Procedure Description: Revised NOI: Hilcorp Energy Company requests permission to recomplete the subject well in the Fruitland Coal formation and downhole commingle with the existing Mesaverde formation. Please see the attached procedure, current and proposed wellbore diagram, plat and natural gas management plan. A closed loop system will be used. Hilcorp will contact the FFO Surface group within 90 days after the well has been recompleted, before any interim reclamation work, to conduct the onsite. A reclamation plan will be submitted after the onsite. **Revised perf range: 3,174' - 3,413'.

HILCORP ENERGY COMPANY
San Juan 28-6 Unit 48A
RECOMPLETION SUNDRY

From: McClure, Dean, EMNRD <Dean.McClure@emnrd.nm.gov>
Sent: Monday, April 15, 2024 6:56 PM
To: Cheryl Weston <cweston@hilcorp.com>; Mandi Walker <mwalker@hilcorp.com>
Subject: [EXTERNAL] Application ID: 323441; 30-039-21872 SAN JUAN 28 6 UNIT #048A

Action 355161

Current Schematic

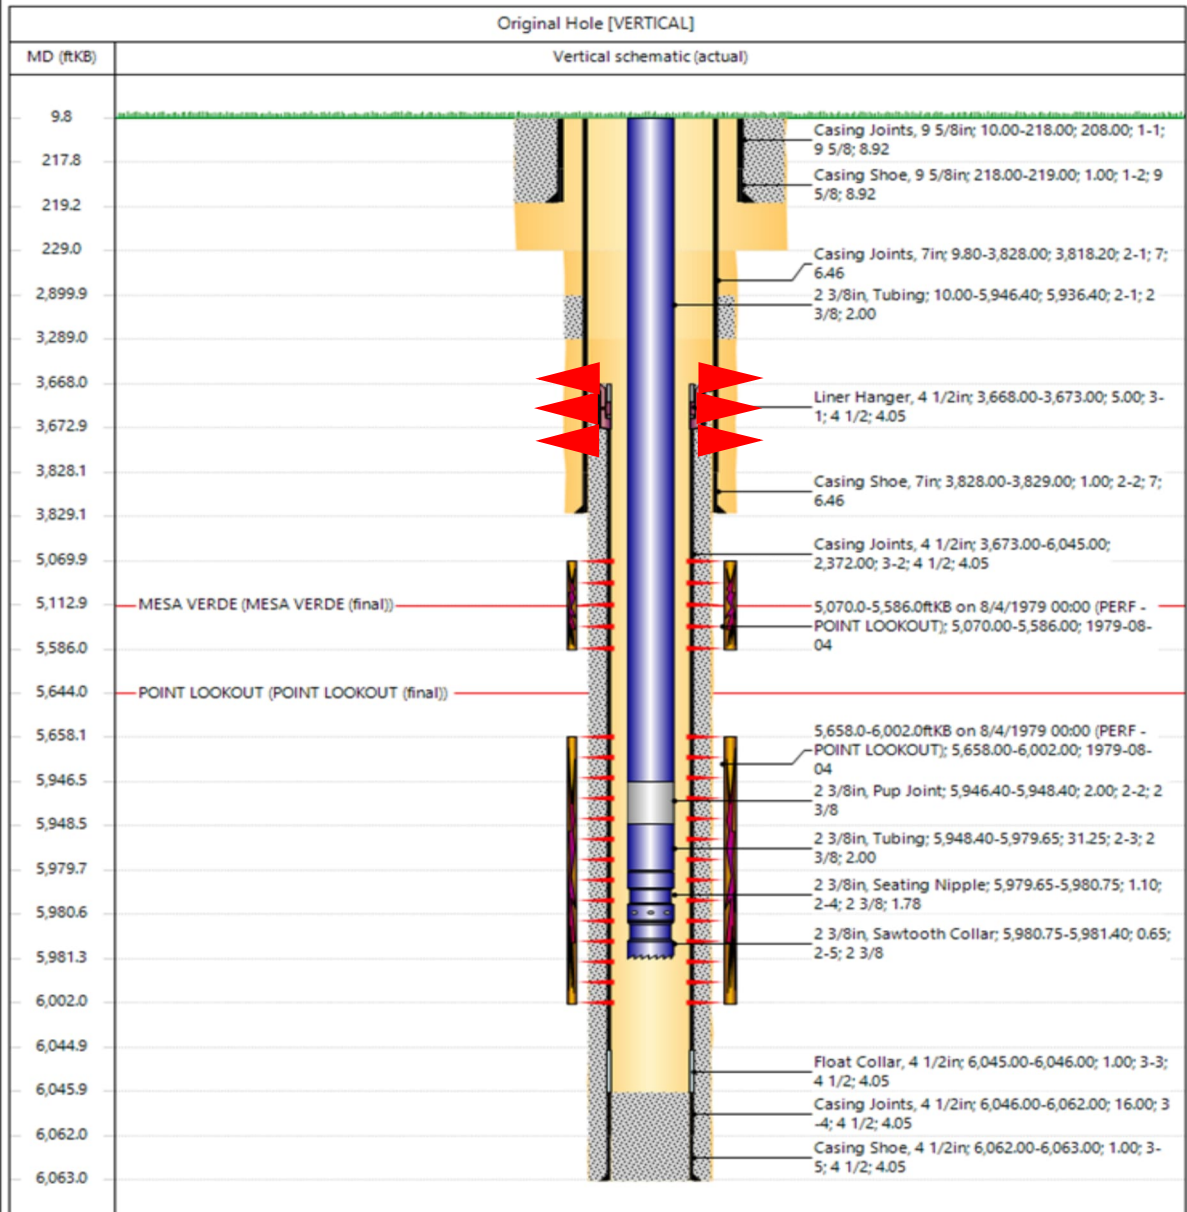
Hilcorp is proposing a perforation range of 3126' to 3445' for the 30-039-21872 SAN JUAN 28 6 UNIT #048A. However, the 30-039-25041 SAN JUAN 28 6 UNIT #441 has the FLC pool picked from 3325' to 3564' which if no Dip is assumed would translate to ~3174' to 3413' within the 30-039-21872 SAN JUAN 28 6 UNIT #048A. Please provide additional information regarding Hilcorp's picks for the FLC and PC.

Hilcorp would like the revised NOI (Action ID 355161) approved, as well the DHC. Please replace the original DHC submitted (Action ID 341636) with the attached copy. It was updated to reflect the revised FRC perf range (3174' – 3413').

The Recomplete NOI was re-submitted on **Action ID 355161**. The FRC perfs were revised to 3174' - 3413'.
